Colgate University
Merrill House Parking Lot & Hamilton Street Driveway Realignment
Date: January 13, 2025

Addendum No. 1

Bid Documents Dated December 18, 2024

Revisions to Site Preparation Plan
Reference Sheet L102

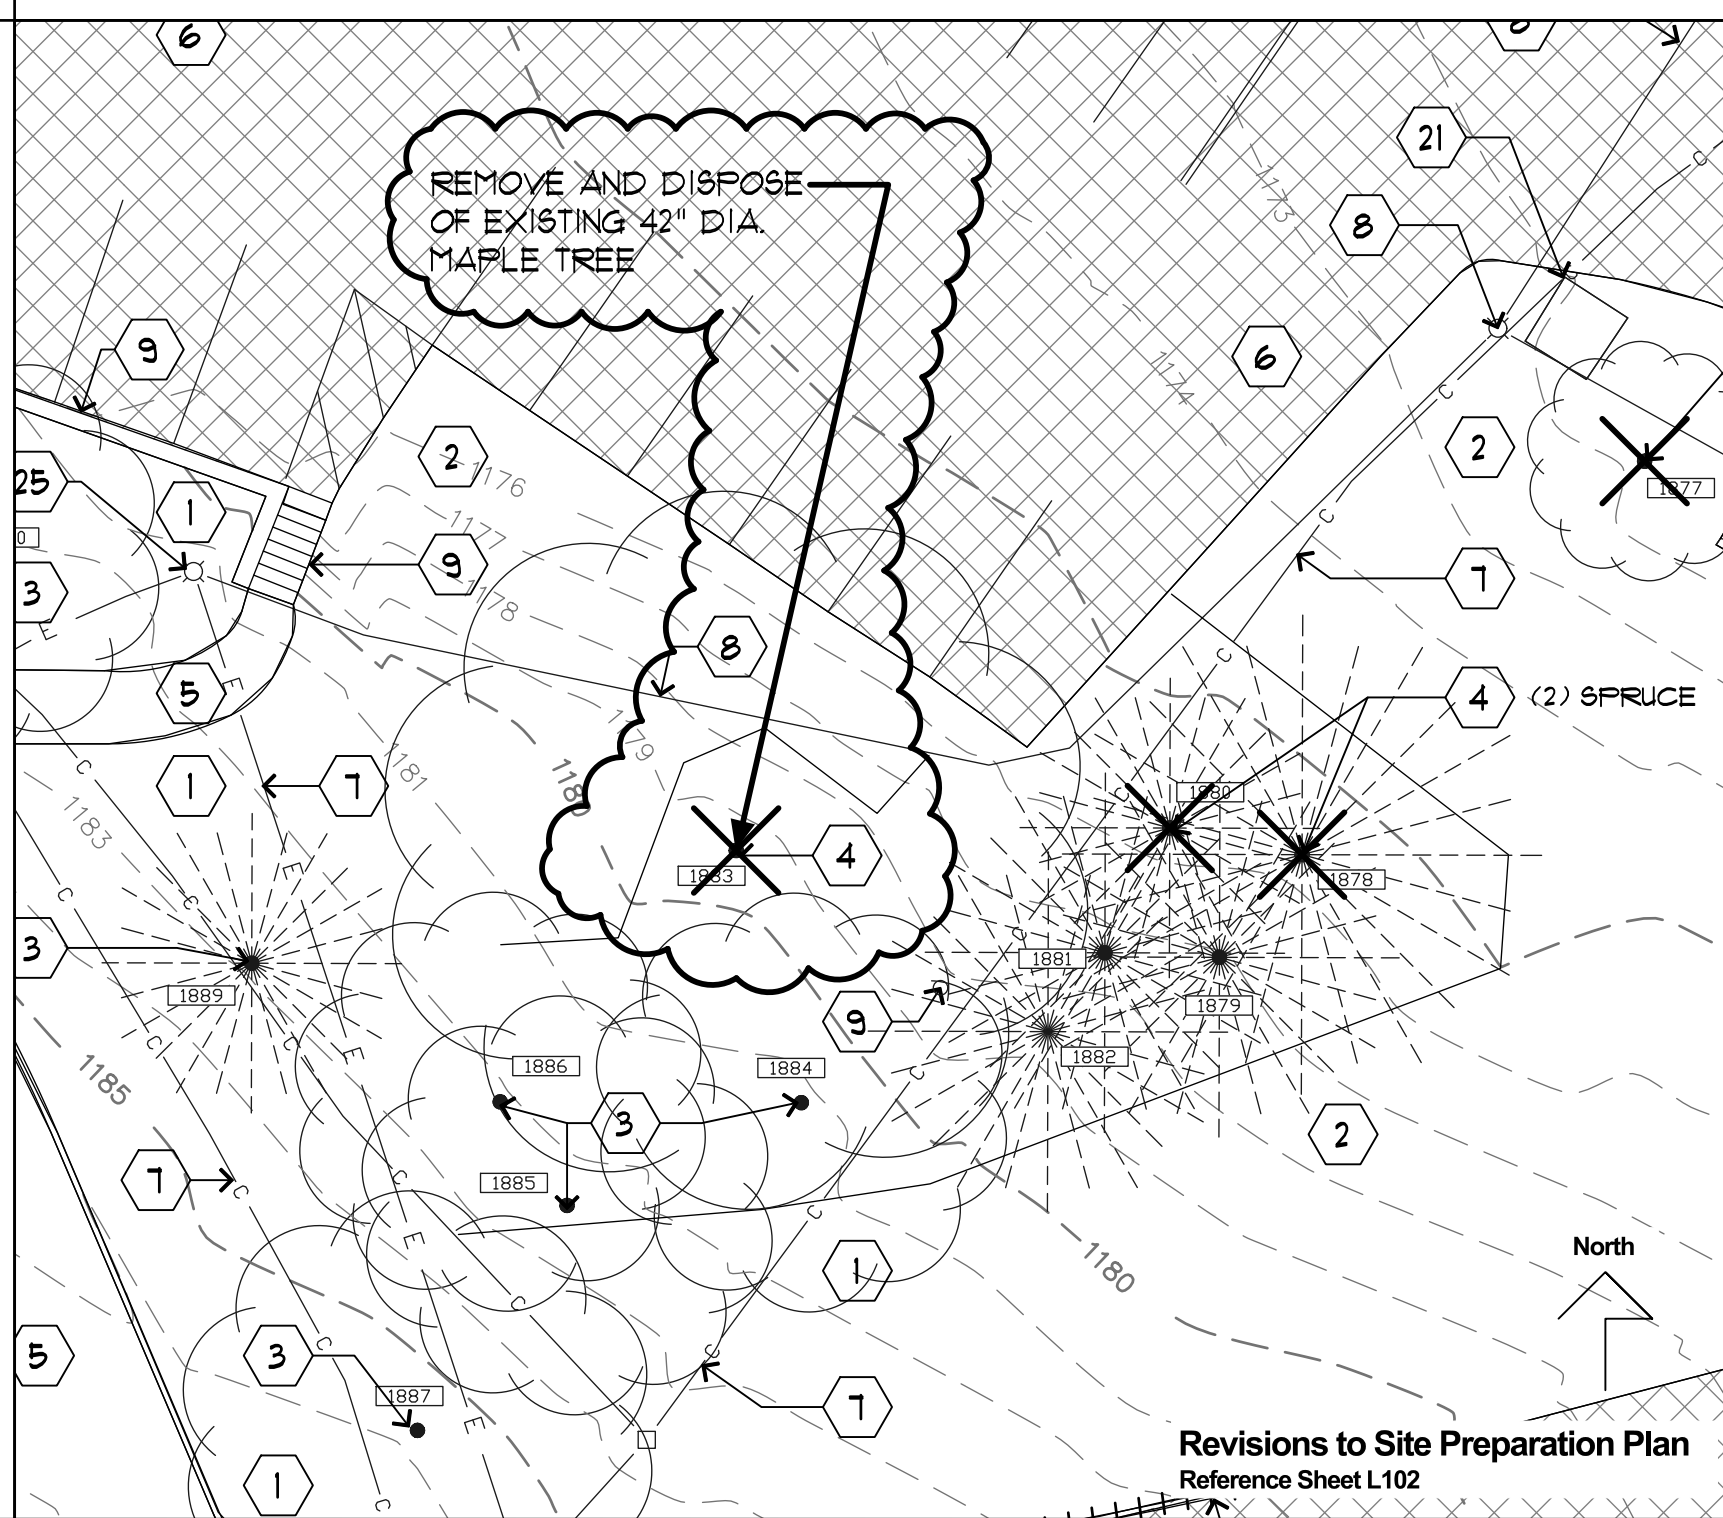
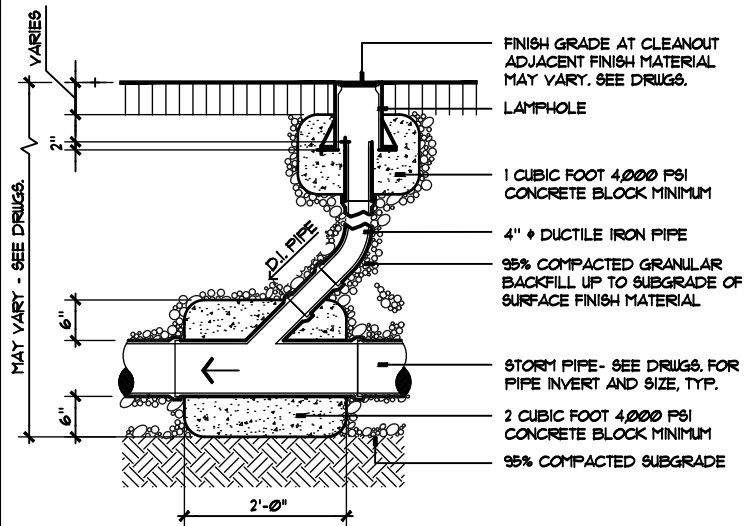
- A. L102 - Site Preparation Plan
1. Remove and dispose of one 42-inch diameter maple tree at south side of parking lot. Refer to attached Addendum Drawing AD1-1.

Revisions to Sanitary Lateral
Reference Sheet L104

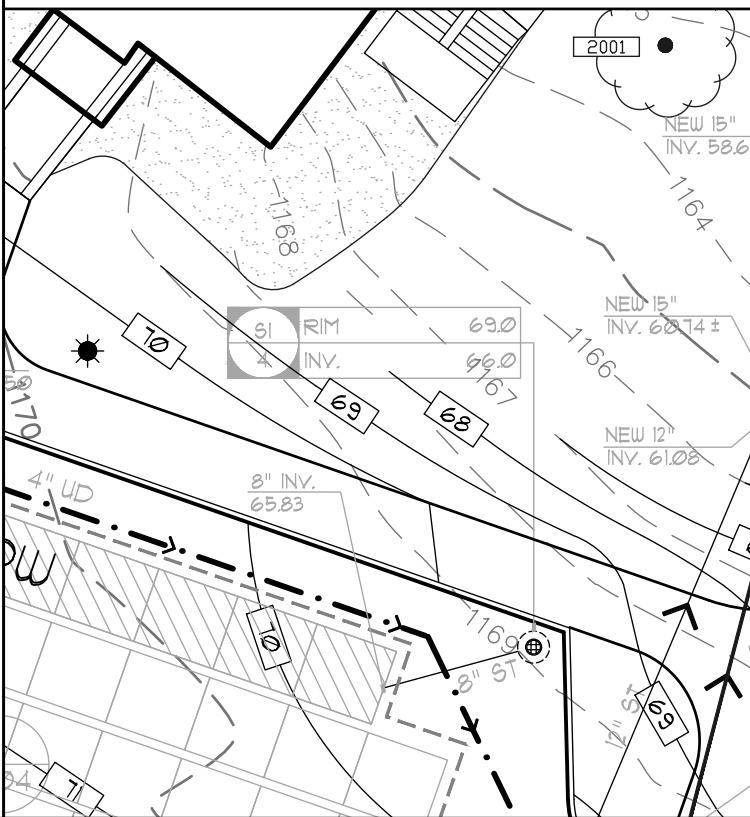
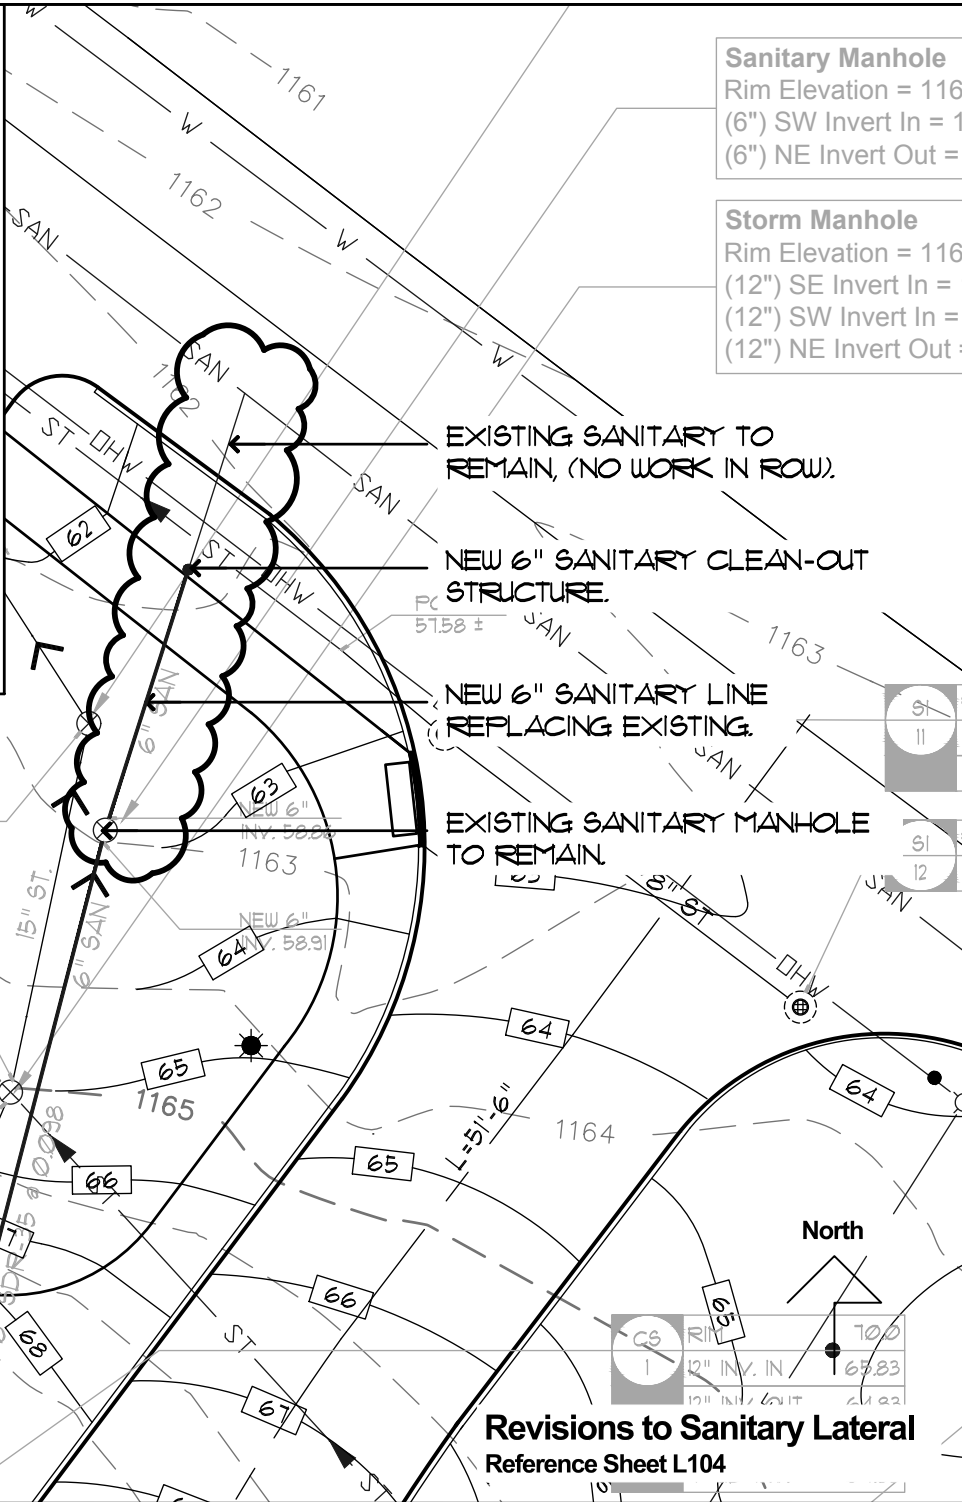
2. Sanitary
 - a. Revise proposed 6-inch sanitary line replacement to tie into existing clay pipe at Village ROW boundary (nearest clay pipe joint located between the proposed curb and sidewalk at Hamilton Street). Provide sanitary cleanout and water-tight connection at tie-in. Refer to attached Addendum Drawing AD1-2.

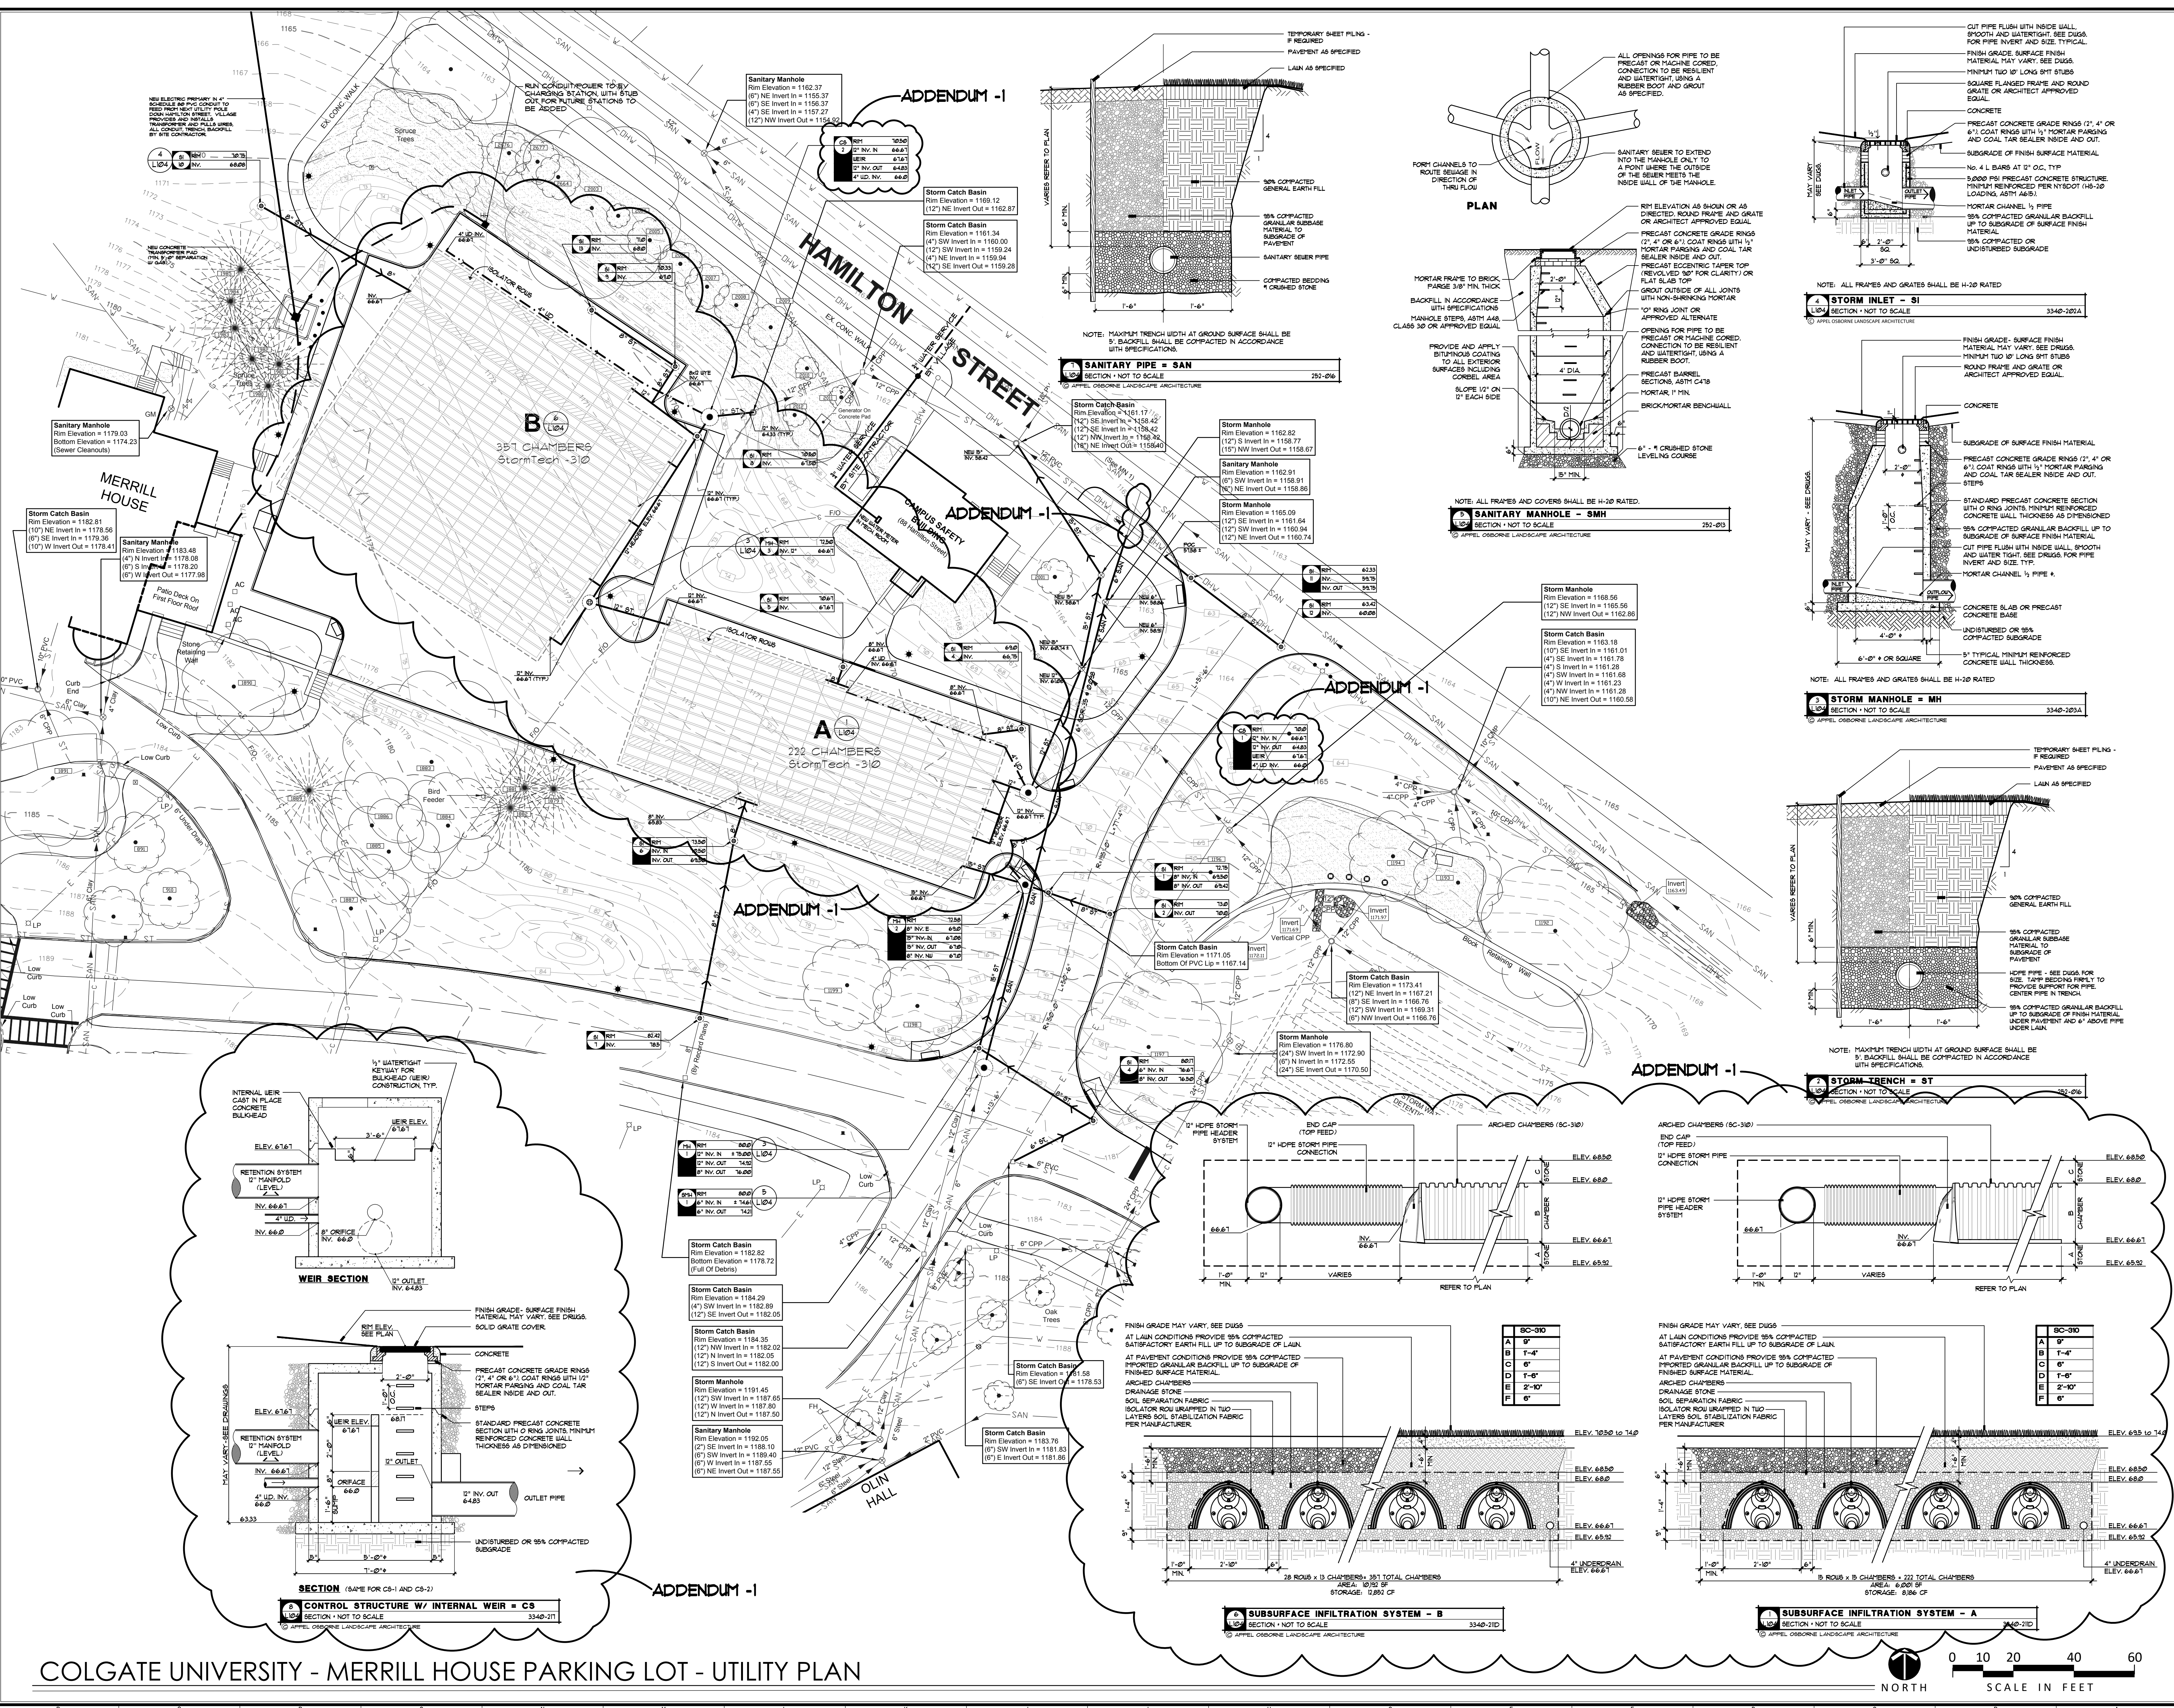
3. Storm Drainage
 - a. Subsurface Infiltration Systems
 - i. Details 1/L104 and 6/L104: Subsurface Infiltration Systems reduced from StormTech MC-3500 system to StormTech SC-310 system.

- ii. Subsurface Infiltration System B footprint has expanded in area, and is now a Deduct Alternate (Alternate L-3).
 - iii. Refer to attached drawing L104 Utility Plan (*reissued*).

DWG: TP363730

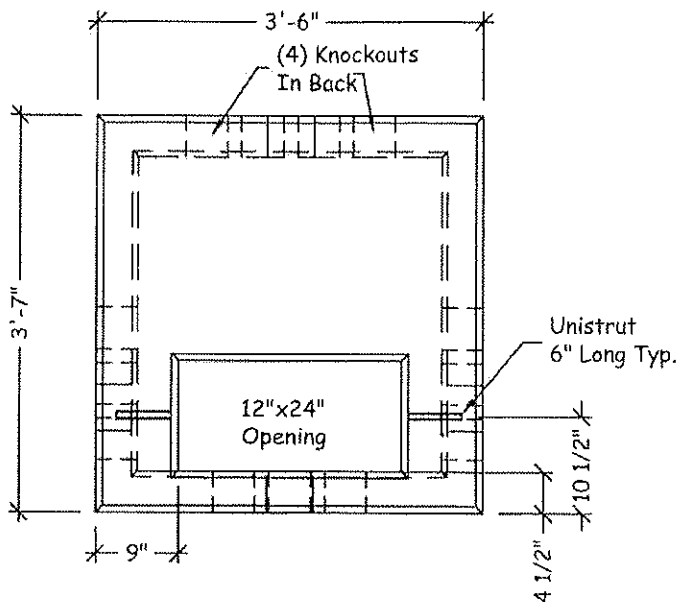
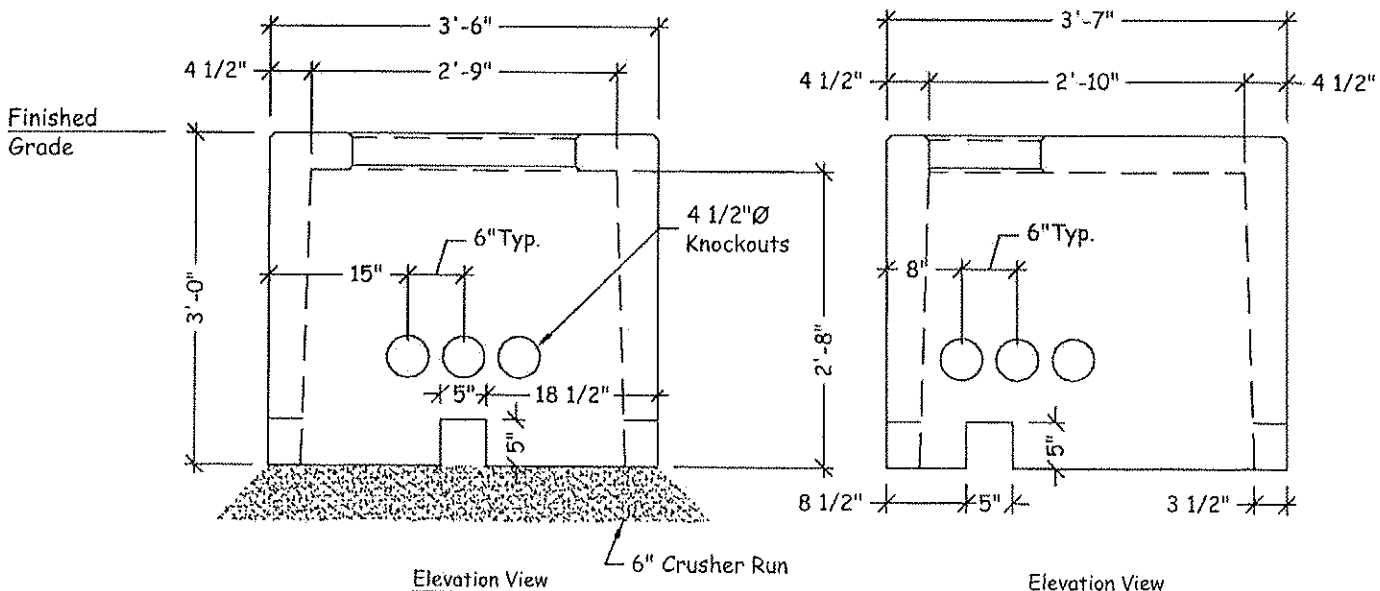
4. Electrical
 - a. Refer to attached shop drawings for transformer vault (Lakelands Concrete Products TP363730) to be provided by the Village of Hamilton (VOH) and installed by the Site Contractor.

- i. Provide minimum 3'-0" of separation between transformer and underground gas line. Coordinate any necessary field adjustments with Owner and VOH.
 - b. Refer to attached 'Photo Supplement - Merrill House Electric Service Entrance & Panels' to inform secondary electrical service and site lighting replacements.

Transformer vault provided by Village of Hamilton (VOH) and installed by Site Contractor. Refer to L107 Site Electrical Notes.
